**From:** Abiel X. Carrillo  
**To:** ["Vinny Perea"](#)  
**Cc:** ["Ron Bohannon"](#); [Cherne, Curtis](#)  
**Subject:** Holly Shopping Center - C18D042D - Stamp Date 2-17-2016  
**Date:** Wednesday, March 09, 2016 4:33:00 PM

Based upon the information provided in your submittal received 2-17-2016, the above referenced Grading and Drainage Plan/Report is approved for Site Plan for Building Permit action by the DRB.

## **Lot 2-A and 3-A Del Norte Plaza**

ENGINEER'S SEAL	LOT 2 DEL NORTE PLAZA ALBUQUERQUE, NM	DRAWN BY pm
		GRADING AND DRAINAGE PLAN	DATE 2-17-16
			DRAWING 2015064-GR
			SHEET # GR-1
RONALD R. BOHANNAN P.E. #7868		TIERRA WEST, LLC 5571 MIDWAY PARK PL NE ALBUQUERQUE, NEW MEXICO 87109 (505) 858-3100 www.tierrawestllc.com	
		JOB # 2015064

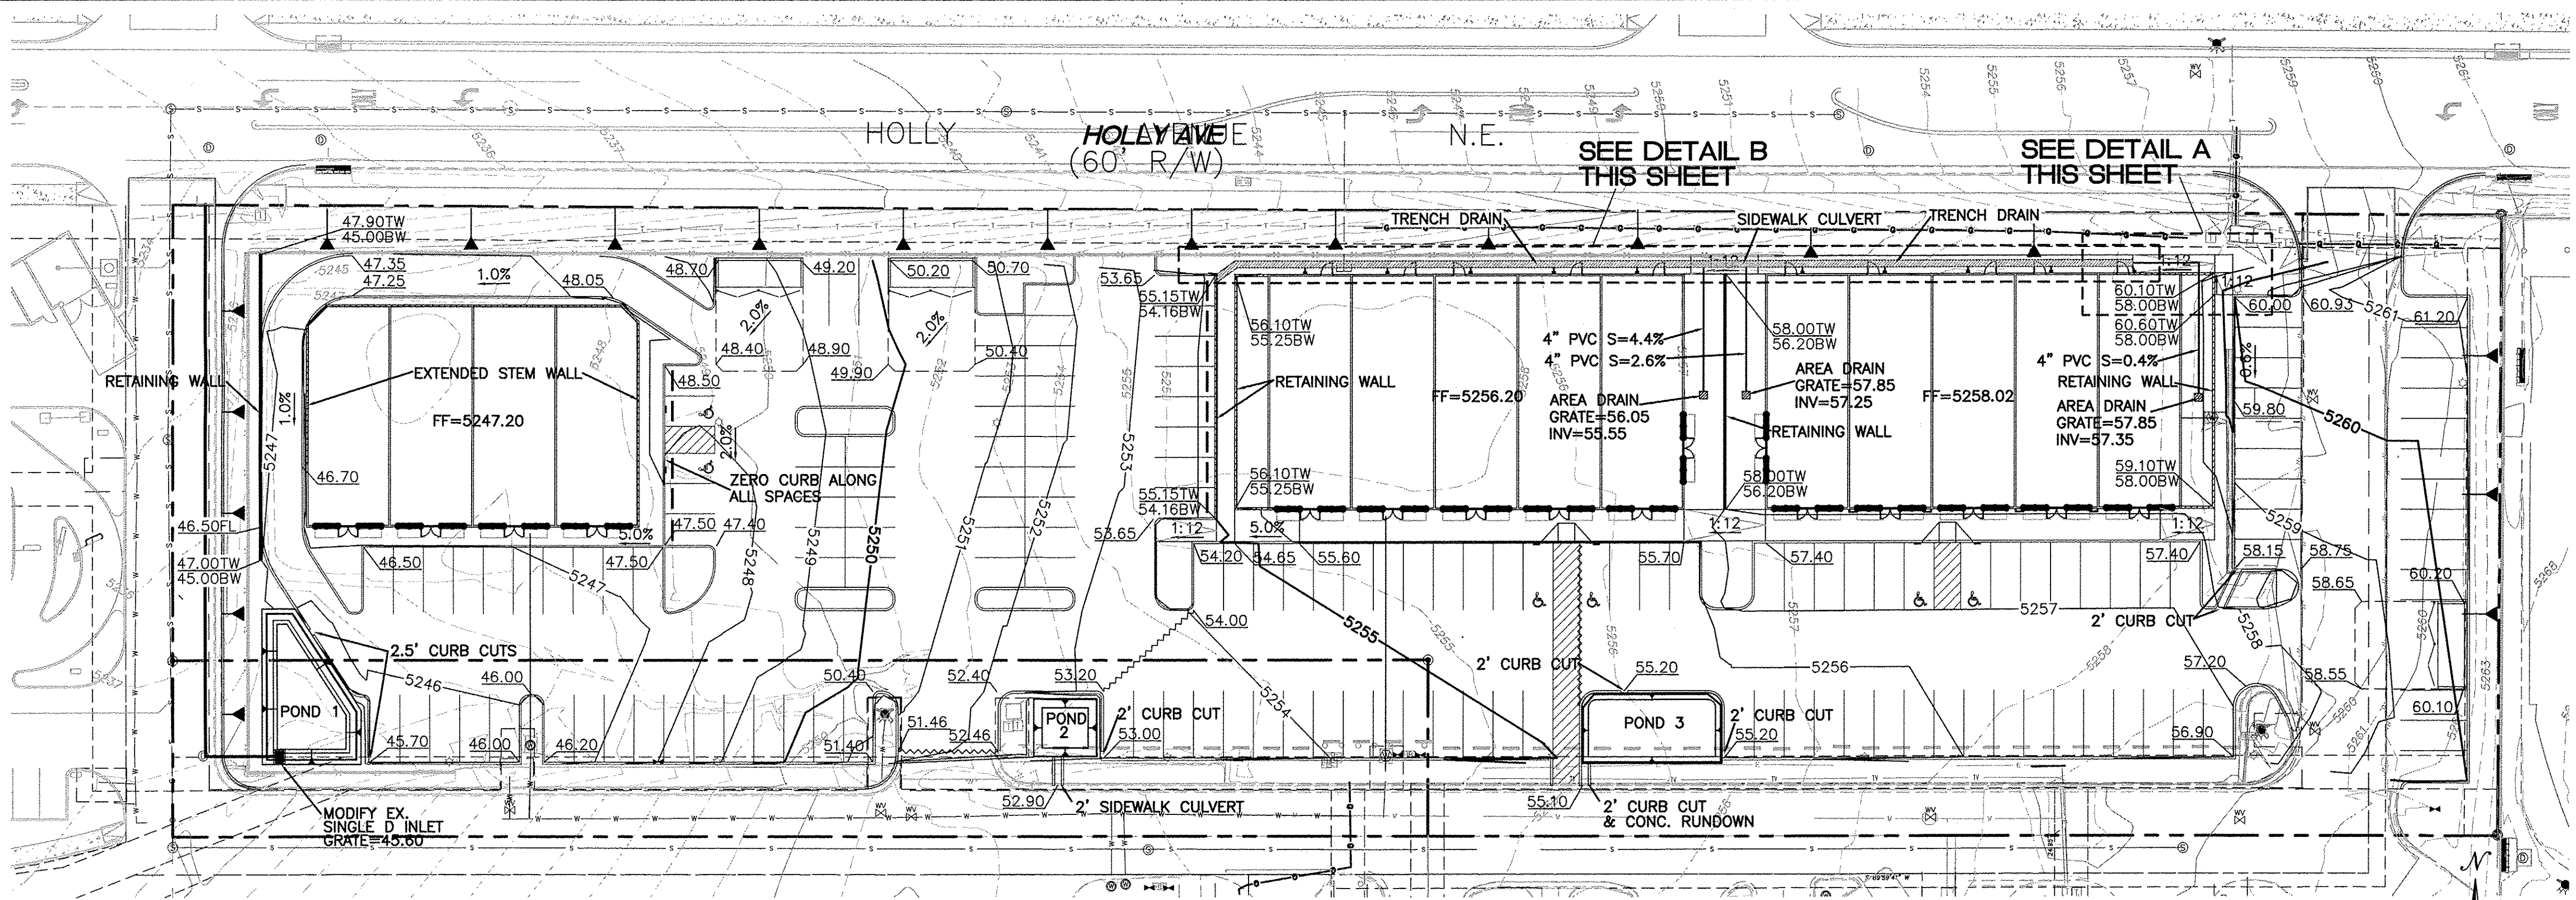
1. An Erosion and Sediment Control plan needs to be approved by the Storm Water Quality Engineer.
2. If Transportation Development will require a sidewalk along the south frontage, the open-channel curb cuts proposed will need to be sidewalk culverts that comply with City Standard Details. The metal plate will need to extend 1-foot behind the sidewalk.

3. The existing inlet in the proposed "Pond 1" is called to be modified. Clarify what the modification involves.
  - a. The grate is shown on the slope of the pond; it is assumed that the box will be perched to ensure that the inlet elevation is level and set at EL 45.60 as called out.

DETAIL A - HC RAMP

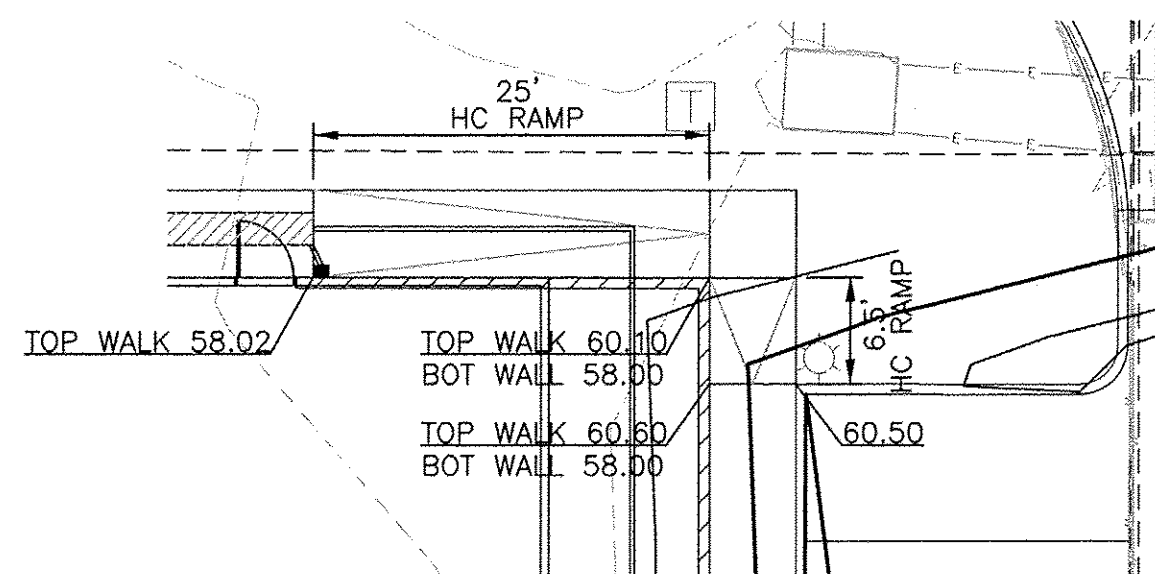
6. Label the intended cross slope of the sidewalk on Section A-A.
7. We recommend shifting the 12:1 wheelchair ramp that is in front of the easternmost retail space of the larger building slightly to the west so that the top of the ramp lines up with the parking curb; this would remove a potential tripping hazard and provide a better turning space for wheelchairs at the top of the ramp.

DETAIL B - TRENCH DRAIN DETAIL

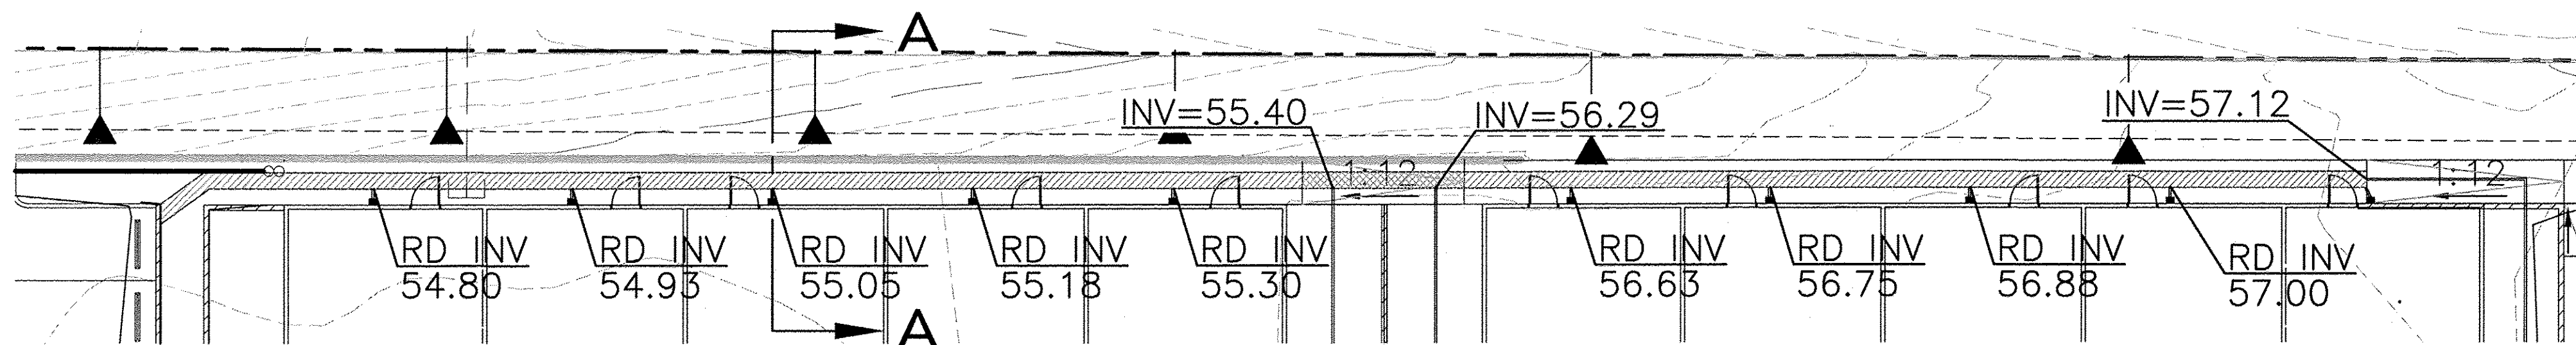
4. Provide benchmark information, unless it is called out on a different sheet of the construction set.
5. Detail B describes the use of a trench drain to provide an outfall for the roof drains of the larger building. A type of grate should be called out that complies with ADA standards and is "heel safe", since it is proposed along the center of the sidewalk. If the sidewalk is intended to drain to the west (without needing to enter the trench drain) we recommend calling out a solid metal top.
